EVEN Hotels + Staybridge Suites

DESIGN REVIEW | RECOMMENDATION MEETING | APRIL 1, 2014

527 Fairview Avenue North, Seattle, WA 98109

Project #s: 3016993 and 6399557

1 AERIAL MASSING
looking South

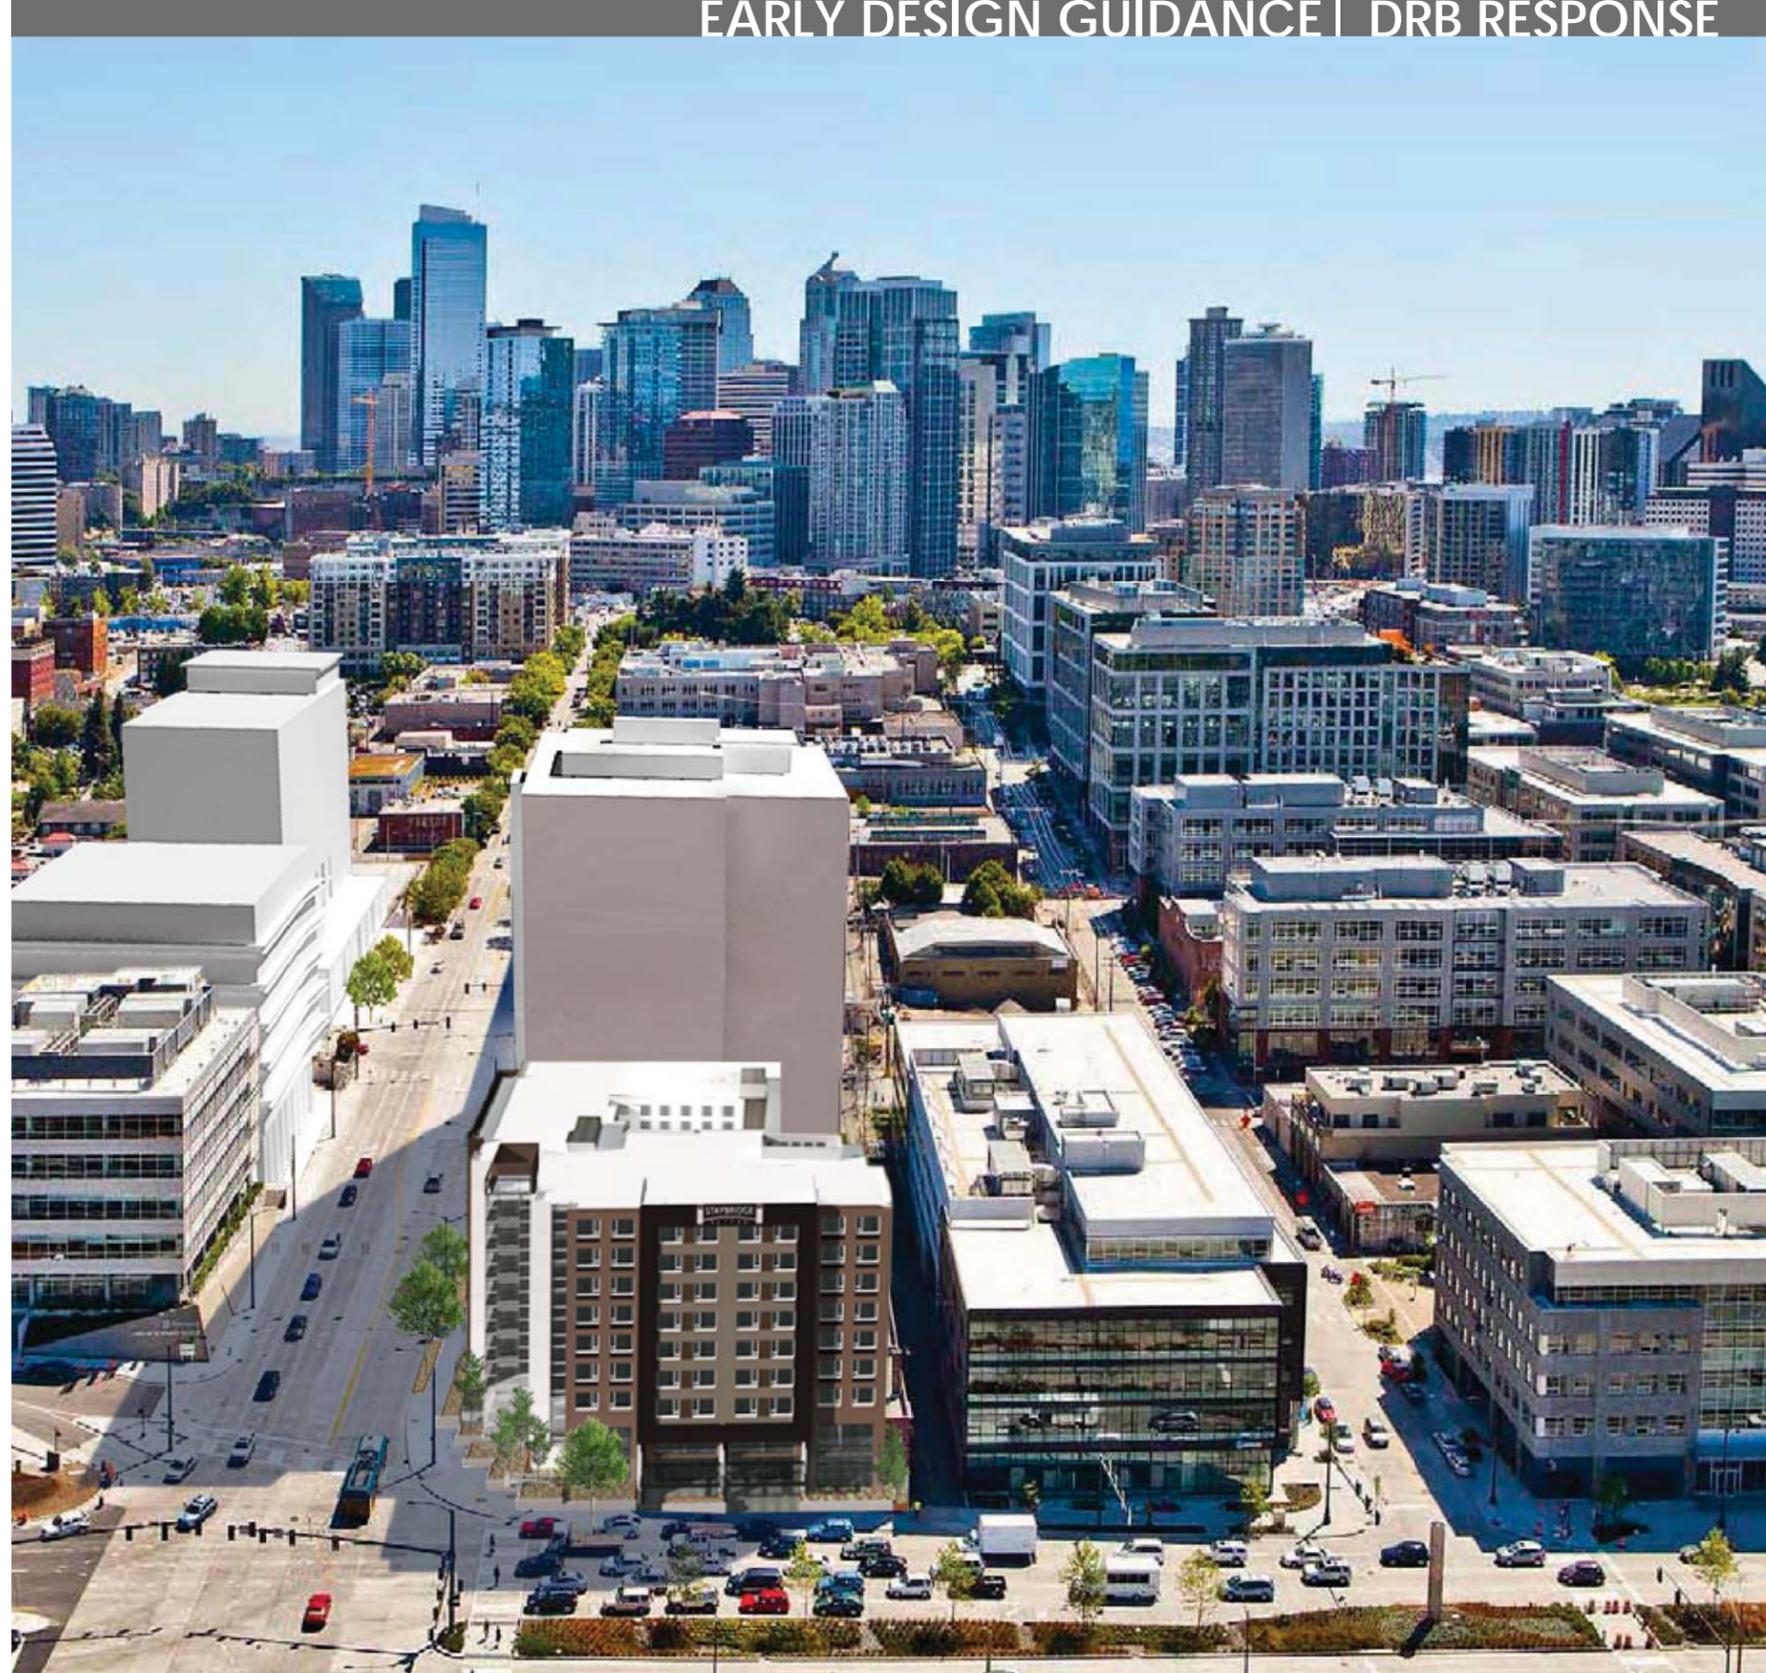
1. Massing: The Board noted that given the location of the site, the building should make a strong architectural gateway statement. The site can also be looked at as a 'bookend' to development along Fairview Ave N to the south and along Mercer Ave to the west. The Board expressed their concern that the proposed massing concepts were too muted to achieve a significant gateway statement. The Board offered the following additional guidance related to massing: (CS2.A.2, CS2.C.1, CS2.I.iii, CS3.B.1)

- a. Study and respond to the existing conditions of the surrounding buildings, especially 500 Boren to the west. (CS3.A.3, DC2.C.3)
- b. Design the corner joining the two wings to be dynamic. (See example #2 shown on page 6 of the EDG packet.) (CS2.C.1)
- c. Avoid a patchwork approach to the massing, the design should not look like infill but should be well integrated into the current massing. (CS3.A.3)
- d. Consider designing the massing to indicate the project is two different hotels using the corner as a transition. (DC1.A.1)
- e. Consider the stepping of the roof line as shown in Option 2. (DC2.B.1)

Response:

The corner feature has been strengthened to create a stronger feature and a neutral connector between the two facades. Strong lighting will be used to emphasize gateway statement along with a terraced base structure bringing landscape features further up the facade. Massing vocabulary has been changed and reinforces the two distinct hotels. Position of the building has been modified stepping back along Mercer to align with 500 Boren to the west – allowing for an activated plaza while extending the streetscape. The vocabulary of the adjacent 500 Boren structure to the West consisting of a landscape foreground and transparent façade have been incorporated into the Mercer Street facade.

1 SW STREET-LEVEL PERSPECTIVE
Mercer Street

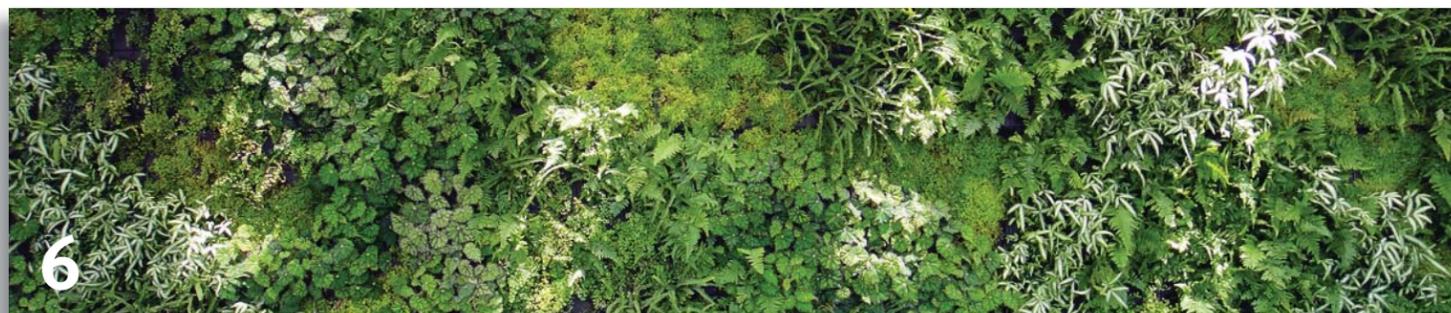
3. Materials: The Board noted that the recent buildings along the south side of Mercer St provide their relief and interest through the use of materials. The proposed concepts appear to be too plain for this gateway location. The Board strongly encouraged the use of quality materials that relate to the recently built structures along Mercer St. and Fairview Ave N. (DC4.A.1, DC2.C.3)

- a. Use quality exterior materials, with refined detailing. (DC4.A.1)
- b. Study and respond to the existing conditions of the surrounding buildings, especially 500 Boren to the west. (DC2.C.3)
- c. Design the scale of the signage to work with moving vehicles. (DC4.B)

Response:

Quality of the materials have increased and are more consistent with buildings along Mercer Street consisting of metal panels with a tone on tone pattern along with more transparency via strong glass statements at both the Mercer and Fairview levels incorporating an extended plaza along Mercer Street.
